From: [Stephen Ubl](#)
To: [Marcia Moermond](#)
Cc: [Nathan Bruhn](#)
Subject: FW: 733 Fairview Ave. N.
Date: Monday, March 11, 2024 1:04:54 PM
Attachments: [image005.png](#)
[image006.png](#)
[image007.png](#)
[image008.png](#)
[image009.png](#)
[image010.png](#)

Below is an email from the owner. The information provided by him does not reflect the material installed in the home at 733 Fairview Ave N. My inspectors took the time to go to Menard's and communicate with his contact, retrieve the correct material information, and affirm that the correct material in the home was installed per manufacture's recommendations.

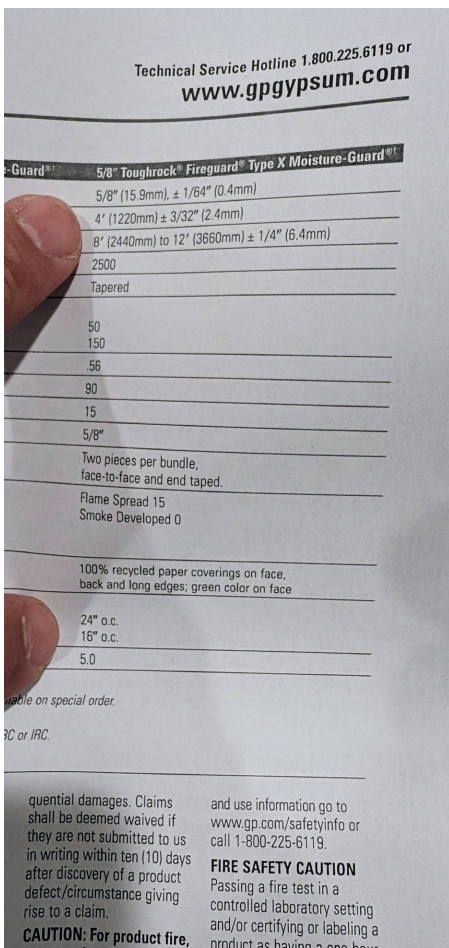
It should be noted, and I want to make very clear since you personally have not been to the home, Stephen, my basement ceilings at the 733 Fairview Ave N home in Saint Paul are **5/8" thick Fireguard (also known as Type X Moisture-Guard), not 1/2" thick**. This is extremely relevant to the forthcoming information to make sure we are on the same page. If, for whatever reason, you do not believe my statement to be correct, I invite you to meet me at the 733 Fairview Home and I personally will show you that I have: 5/8" gypsum board installed in the basement ceilings and not 1/2" thick.

To this end, as illustrated in the Georgia-Pacific manufacturer's installation recommendation instructions for the 5/8" Toughrock Fireguard ("green" board) Type X Moisture Guard gypsum sheetrock that has been installed in the 733 basement ceilings, Framing Spacing, Maximum for Ceilings is **16" o.c., not 12" o.c.**

To this end, the basement 5/8" ceilings at the 733 Fairview Ave. N. property remain in compliance with both the CertainTeed ("purple" board) and the Georgia-Pacific ("green" board) manufacturer's installation recommendations of a minimum of 16" o.c.

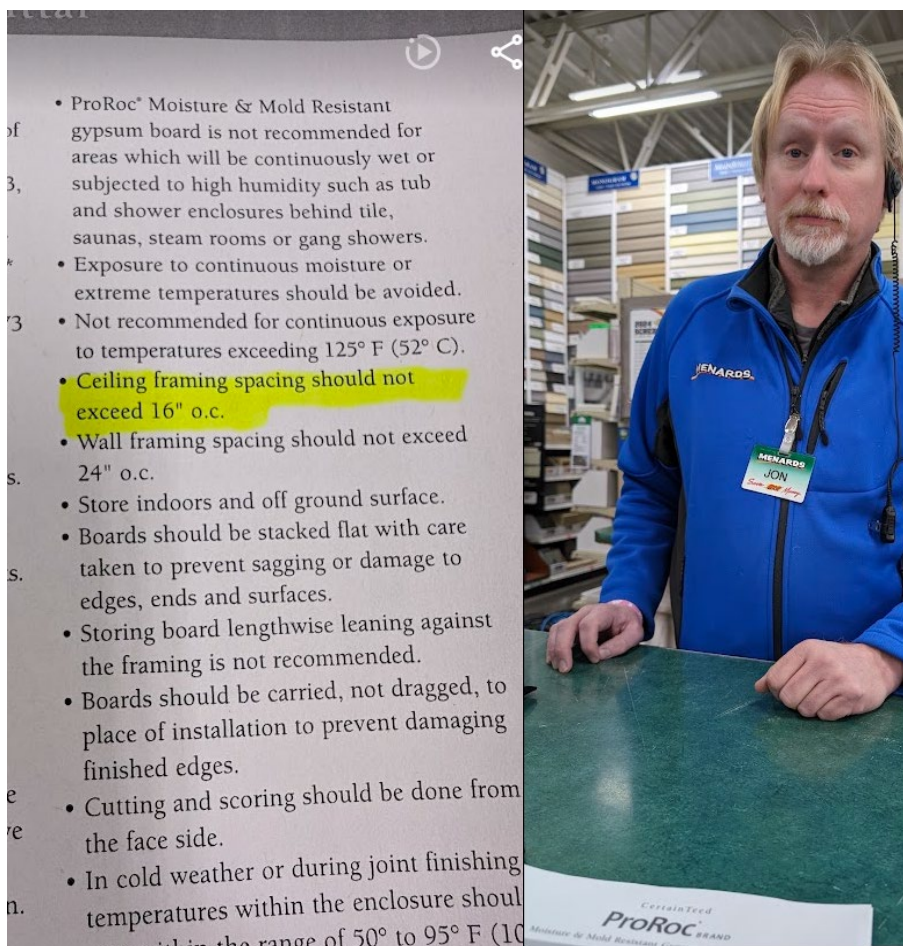
Tuesday, after our meeting, I went to Menards. I eventually was able to speak with Jon, in the building center, who is familiar with my situation. I asked him to provide me with the literature on the manufacturer's installation instructions for the moisture-mold-resistant sheetrock to determine whether what I did in my home complied with the manufacturer's installation recommendations. I asked him specifically whether the moisture & mold resistance gypsum board he sold me from Menards to install on many of the walls and ceilings, per the manufacturer's instructions, called for it to be installed on 16" on center or whether it required a lesser distance. Without saying a word, Jon got on his screen, printed, and with his yellow highlighter, marked the following and slid the paper over to me: **Ceiling framing spacing**

should not exceed 16" o.c." Based on the above, I complied with the manufacturer's gypsum board moisture-mold-resistant installation recommendations, Stephen.
